ADDENDUM # 001

Project: Lodi Unified School District
Tokay High School
AG Area Site Improvements
19six #: 23381
DSA #: 02-122224
Bid #: 6388

Date: September 5, 2024

ACCESSIBLE GATE

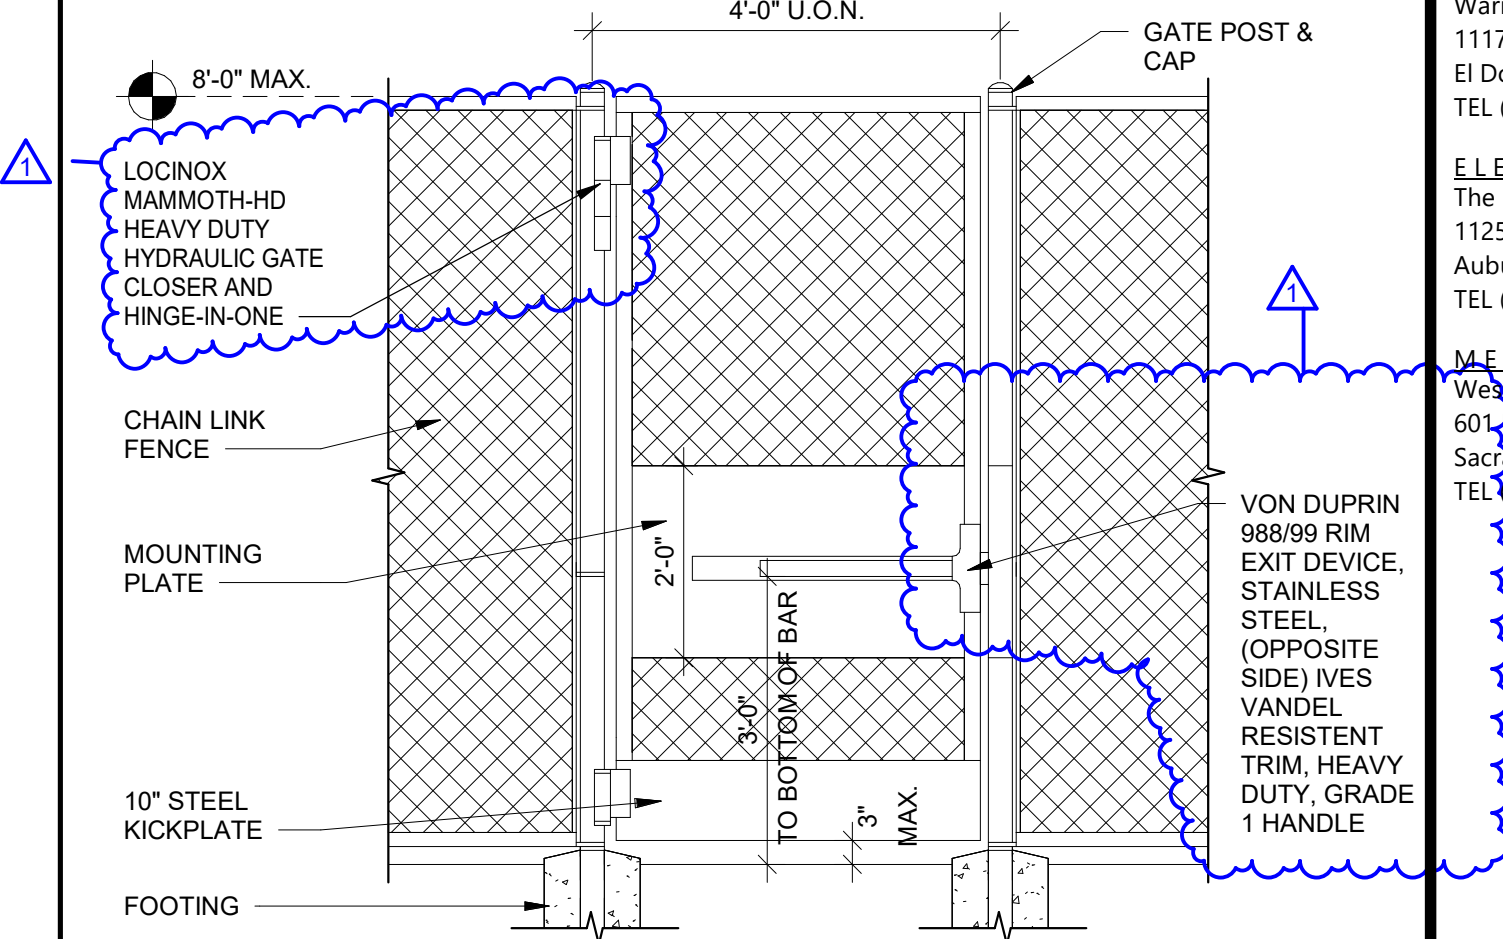
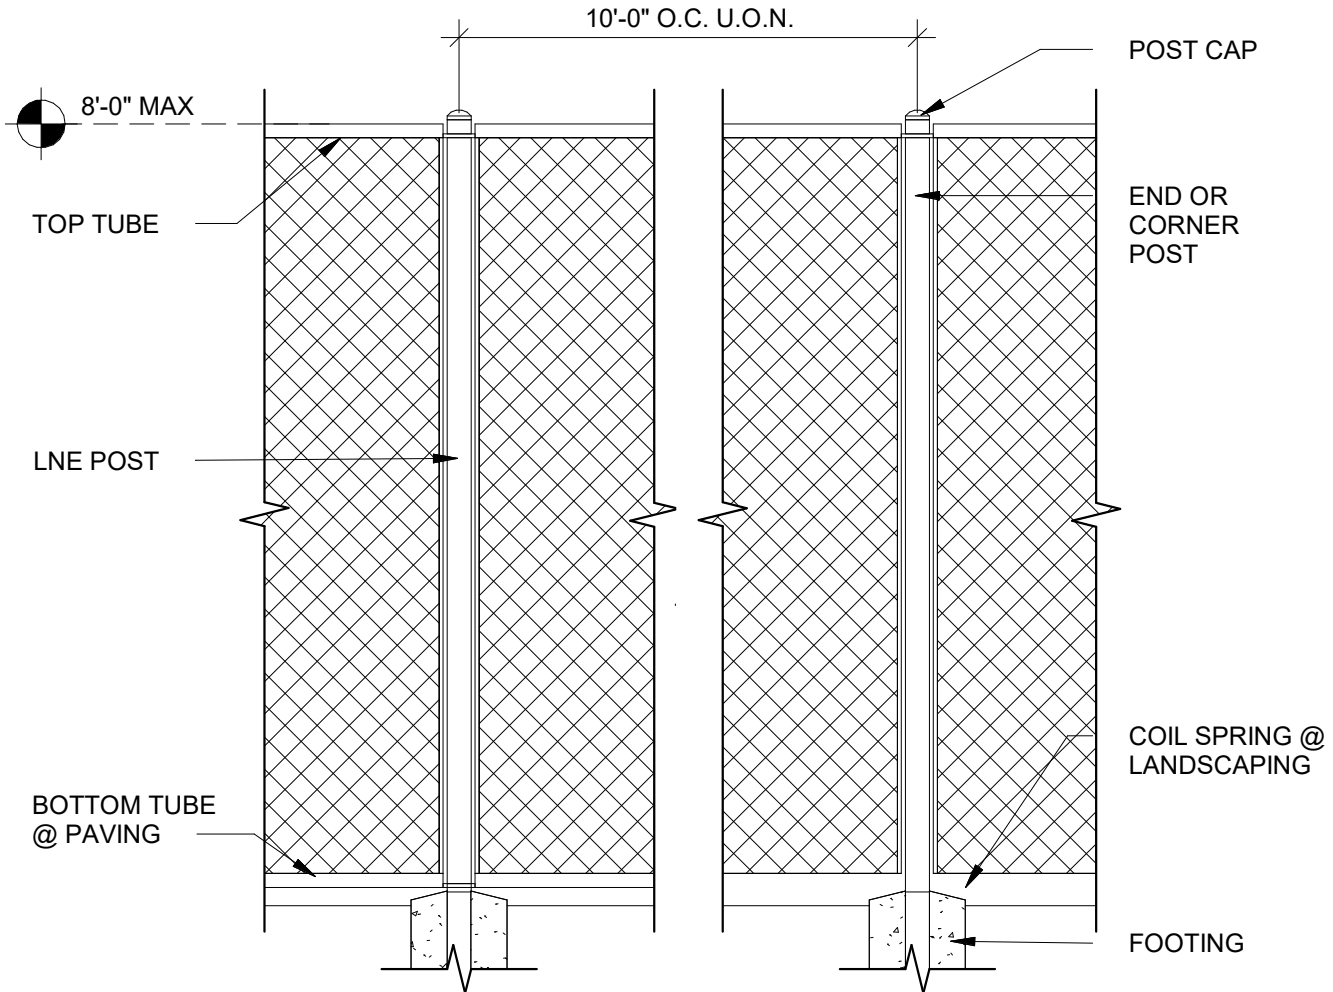
Item #2: **Accessible Gate** Installation of additional ADA compliant gate with description of hardware associated with both gates.

32.31.D	(N) SINGLE 3'-6" WIDE CHAIN LINK GATE WITH PANIC HARDWARE. SEE 3A.11-1
32.31.G	(E) 8'-0" TALL CHAIN LINK FENCE
32.32.F	(E) 20' WIDE SWING GATE WITH KNOX BOX
